Rover Service News Letter No. 45

TO ALL DISTRIBUTORS AND DEALERS

Fig. 1. Welding breather pipe baffle.

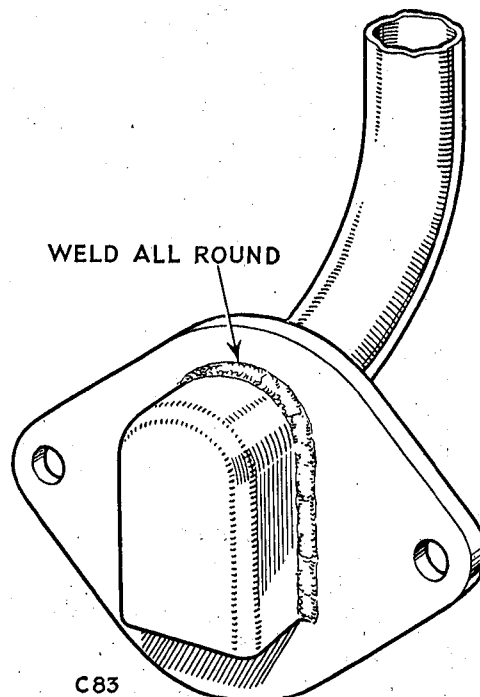
- Item 50 **OIL CONSUMPTION 1954 "90"** It has been found that the oil consumption on some "90" cars has increased after long high speed runs due to oil being thrown through the tack welding between the baffle plate and the cover plate into the oil breather pipe.

The breather pipe has been modified on Production from Engines number 45303920 onwards by welding all round the baffle.

Where a complaint of high oil consumption after long runs is received, a check should be made in the vicinity of the breather pipe for traces of oil. If oil is found the breather pipe should be removed and the baffle welded all round as shown in the sketch below.

Fig. 2. Front mounting for exhaust pipe.

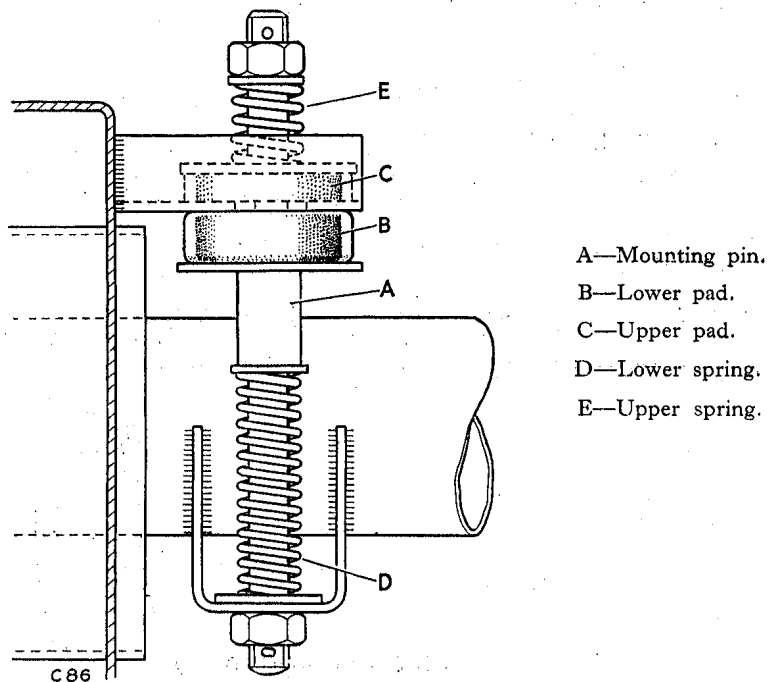
Item 52 EXHAUST MOUNTING To ensure that vibration is not transmitted up the exhaust system, a re-designed front mounting pin with a spring at top and bottom has been introduced from:—

Any earlier 1954 Car can be modified if the parts above are supplied and in addition one plain washer, Part No. 2550, and one split pin, Part No. 2389, are also used. The sketch below shows the method of assembly.
